# Staff Summary Report

**SUBJECT:** Hold a public hearing for a Use Permit and Development Plan Review for **Lakes Towne Center – Phase I** located at 777 E. Baseline Road.

**DOCUMENT NAME:** DRCr\_LakesTowneCenter\_012208

**COMMENTS:** Request for **LAKES TOWNE CENTER PHASE I (PL070361)** consists of the first phase of a series of single-story retail buildings; a multi-tenant 10,200 s.f. Shops A and a 119,328 s.f. Lowe's building and 27,265 s.f. Garden Center are 156,793 s.f. of the total approximately 189,375 s.f. on 16 net acres, in the PCC-2 Planned Commercial Center Two, Zoning District. The request includes the following:

**1 SITE PLAN**  
 SCALE: 1" = 40'-0"

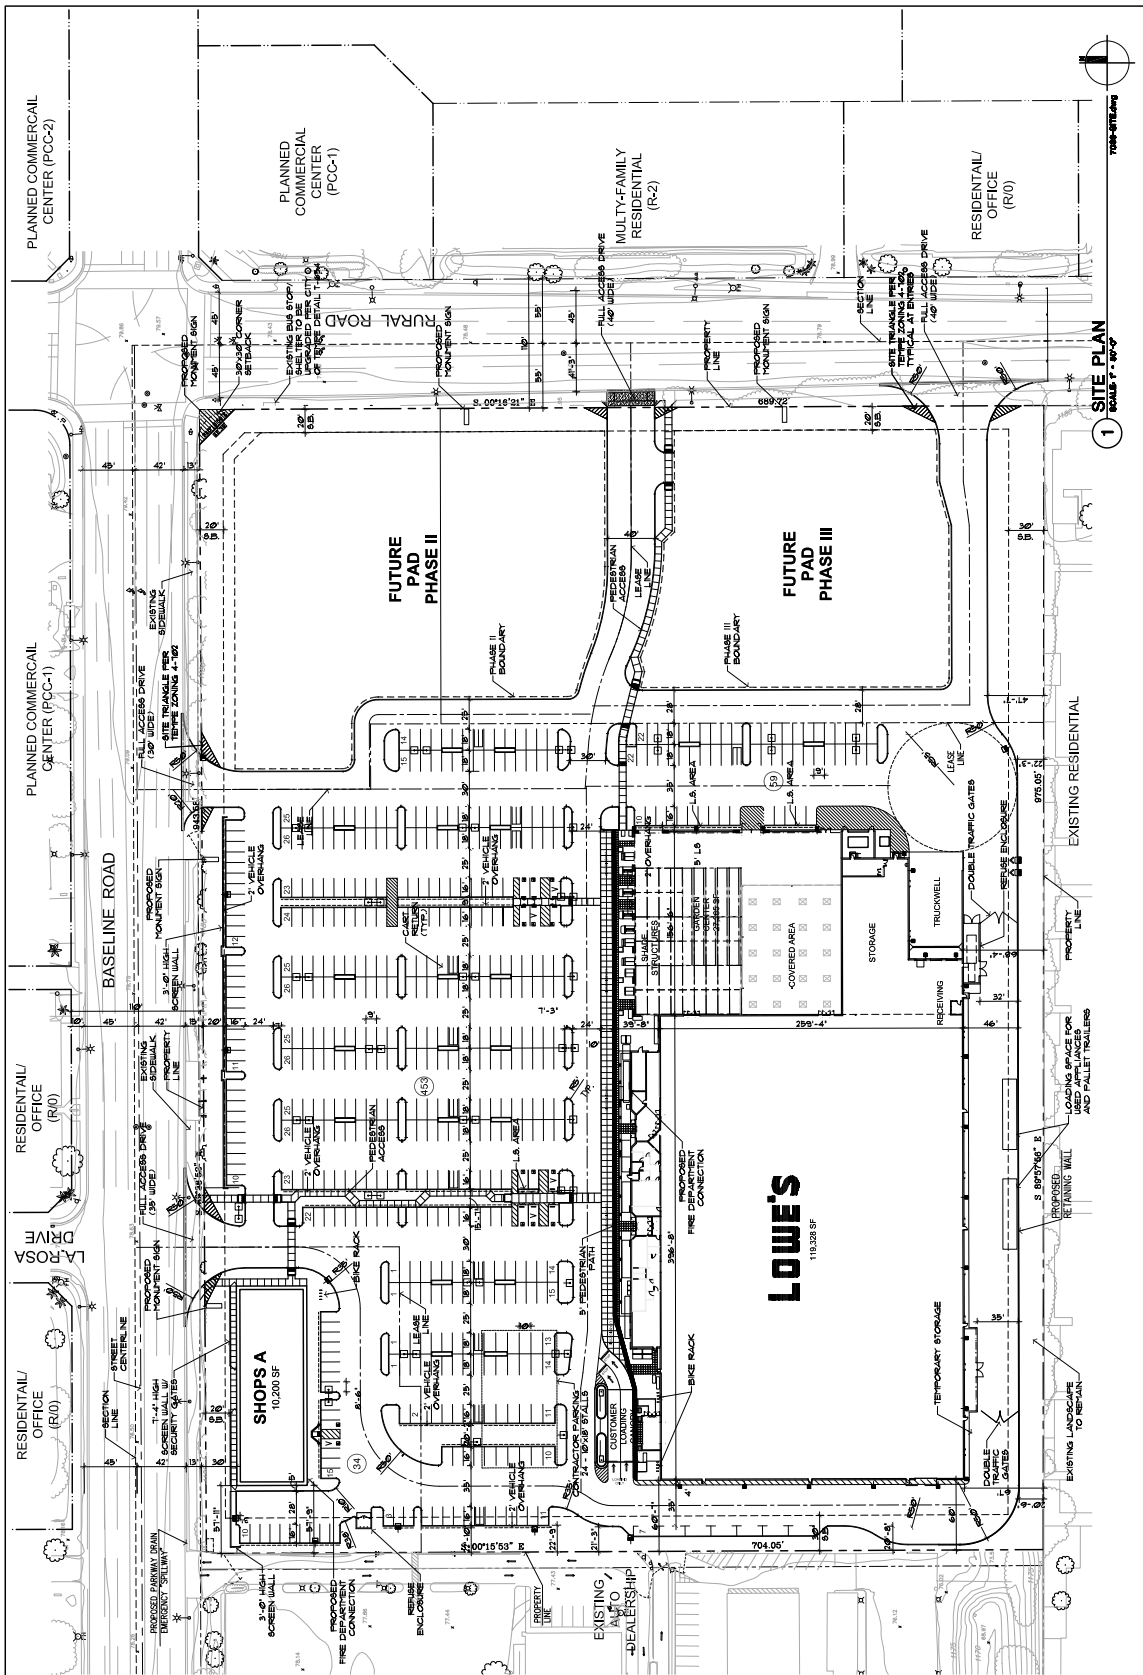
The site is located on the south west corner of Baseline and Rural Roads. The site has a auto dealership (PCC-2) to the west, residences (R-2) to the south, a proposed bank in the existing gas station site (PCC-1),

The site has multiple driveway entrances, with separate pedestrian pathways to facilitate pedestrian access. Sidewalks connect each of the proposed pad sites to the main tenant, to the public sidewalks and to the different parking areas. A separate pedestrian path has been designated adjacent to the Lowe's outdoor retail area, to minimize conflicts with pedestrians and vehicles in the loading zone. Clear and well lighted walkways connect building entrances to one another and to adjacent sidewalks; special consideration was given to ensure that the loading zone and pedestrian path by the Lowe's building were lit for safe evening traffic. Accessibility is provided in conformance with the Americans with Disabilities Act (ADA).

Vehicular circulation is designed to minimize conflicts with pedestrian access. A wide shaded pedestrian path connects from the Baseline Road public sidewalk. Traffic engineering staff is working with the applicant to address the required driveway entrances to the site a condition of approval has been included to address this (see p. 11 Driveways). Traffic impacts will be minimized in conformance with the city transportation policies, plans and design criteria.

The placement of the Lowe's building at the south west corner of the site provides natural surveillance of the parking lot and pedestrian areas, but creates a large expanse (approximately 500 lineal feet) of hidden area behind the building, with little to no traffic or visibility. To alleviate this security concern, the Police Department has advised that an 8' masonry wall, enhanced lighting and surveillance equipment be required (see p. 10 Security Requirements), to reduce the potential of criminal activity behind the building.

Proposed outdoor display and sales areas will require a use permit. As part of the site plan review, this request has been conditioned (see condition 12) based on future approval of a use permit, to locate all outdoor retail displays out of view of Baseline Road, with the exception of the temporary garden lot proposed for seasonal plant sales. The rental trucks and utility trailers would be located at the west end of the lot, near the proposed utility building display area. All of these uses must also be located outside of the required parking spaces serving Lowe's and Shops A. Shops A is restricted to retail uses only, no restaurant uses (condition 11); parking requirements for phase one are 432 spaces for the indoor retail and 55 for the outdoor retail, for a total of 487 parking spaces; 546 spaces are provided.

The proposed development meets or exceeds the required building setbacks. The side yard building setback is 30'; the proposed 48' building height would require an 18' step back from this setback; the building is set back 67' from the south side yard setback, providing a sufficient buffer to the residents to the south.

6. Provide 8'-0" wide public sidewalk along arterial roadways, or as required by Traffic Engineering Design Criteria and Standard Details.
7. Provide service yard and mechanical yard walls that are at least 8'-0" tall as measured from adjacent grade and are at least the height of the equipment being enclosed, whichever is greater. Verify height of equipment and mounting base to ensure that wall height is adequate to fully screen the equipment. Locate electrical service entrance sections inside the service yard, as indicated.

8. Provide gates of steel vertical picket, steel mesh, steel panel or similar construction. Where a gate has a screen function and is completely opaque, provide vision portals for visual surveillance. Provide gates of height that match that of the adjacent enclosure walls. Review gate hardware with Building Safety and Fire staff and design gate to resolve lock and emergency ingress/egress features that may be required.

9. Provide upgraded paving at each driveway apron consisting of unit paving. Extend unit paving in the driveway from the back of the accessible public sidewalk bypass to 20'-0" on site and from curb to curb at the drive edges.

11. Shops A shall not have any restaurant uses, or shall provide required parking for this use.
12. Use permit is required for outdoor display, retail sales and vehicle rentals; this is not part of this approval.

- a. Contingent upon future approval of these use permits; locate outdoor retail sales out of view of Baseline Road, with the exception of the temporary garden lot proposed for seasonal plant sales.

- b. The rental trucks and utility trailers will be located at the west end of the lot, near the proposed utility building display area.
  - c. All of these uses must use surplus parking spaces and shall not use any of the required parking.
